MEMORANDUM

From: Roland Bartl, AICP, Planning Director

Subject: **540 Mass. Ave. – Application for Street Determination (Flannery)**
Town Atlas Map F2B, Parcel 15

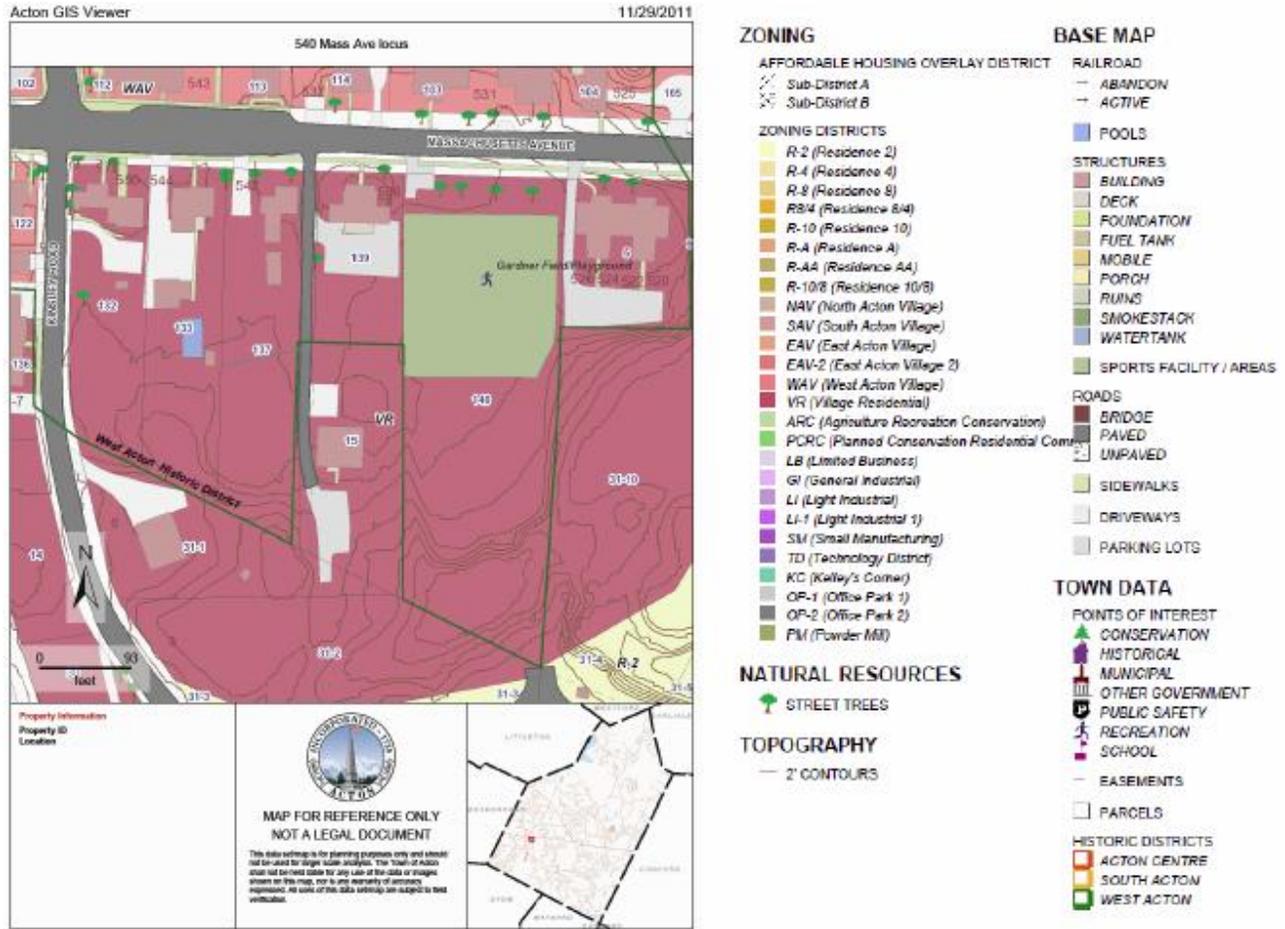
Following is an aerial view of the locus from the Town's GIS system. The highlighted area comprises the parcels of land with rights to use the way for access and egress.
